PLANS OF PROPOSED IMPROVEMENT ON THE
PRIMARY ROAD SYSTEM
POLK COUNTY
PCC Pavement Widening
Des Moines River to 500 ft N of Maury Ave in Des Moines

NHSN-069-4(110)--2R-77

DMWW U3 First Plan Review Comments Sent 1/28/25.
For questions or comments please contact the following:

D5 PLAN - Date: 07-19-24

MAURY ST

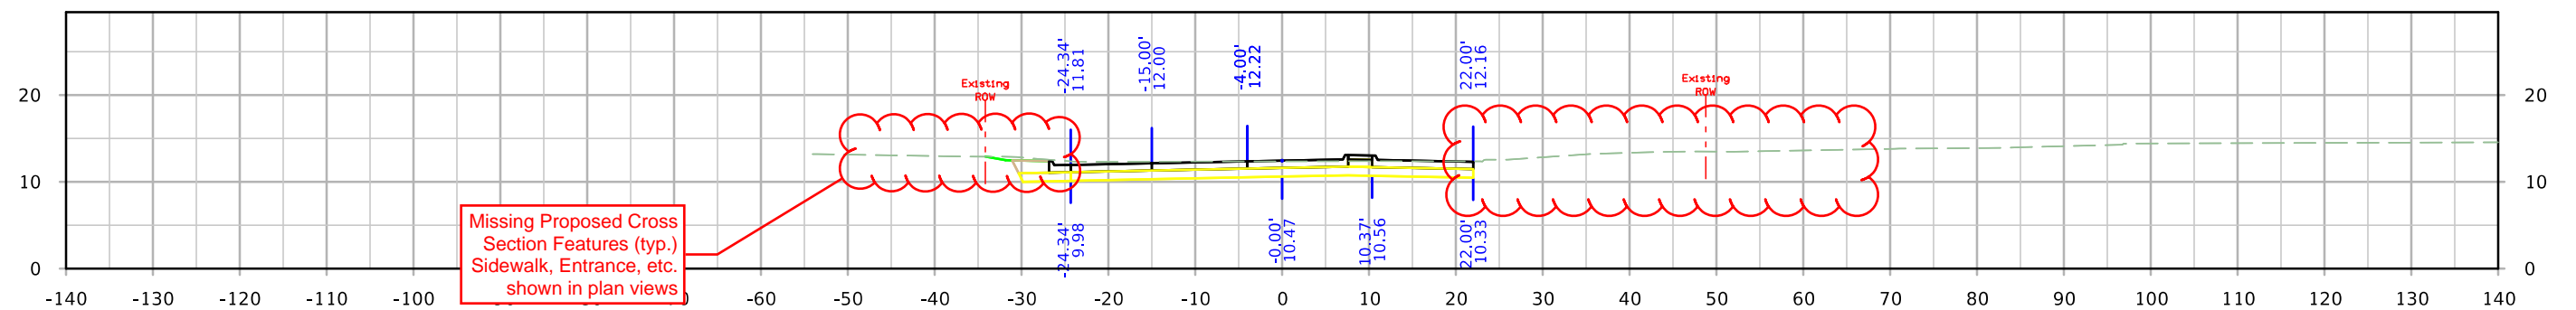
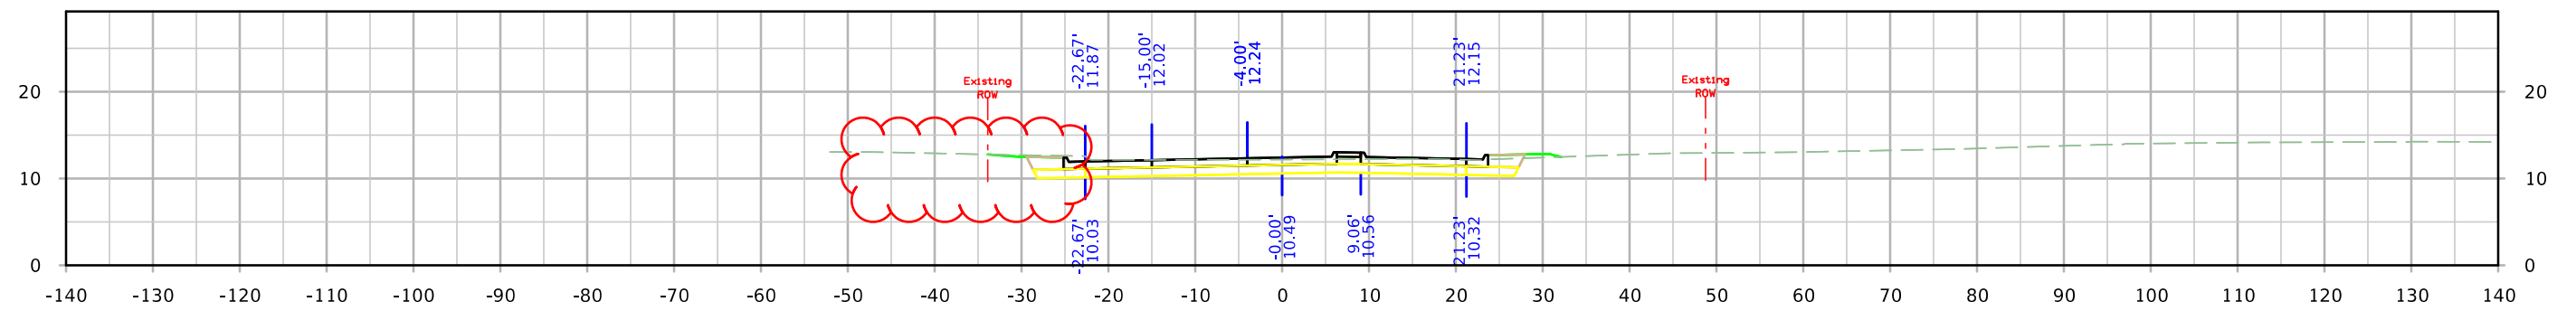
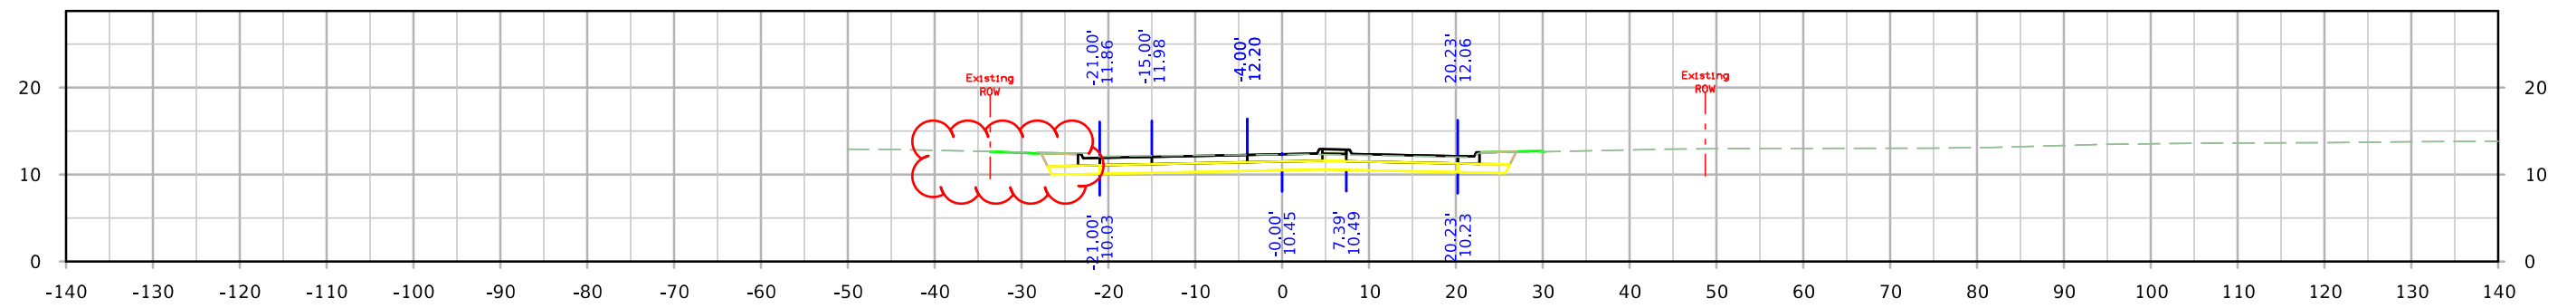
Missing Proposed Cross Section Features (typ.)
